ADA Curb Ramp New Construction Inspection Form (Perpendicular)

Nw 294th

23885.56

Nw 292nd

PERPENDICULAR RAMP (PR)

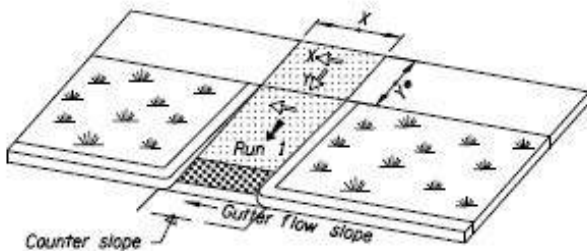
IITS RR1 fails, crack in TS
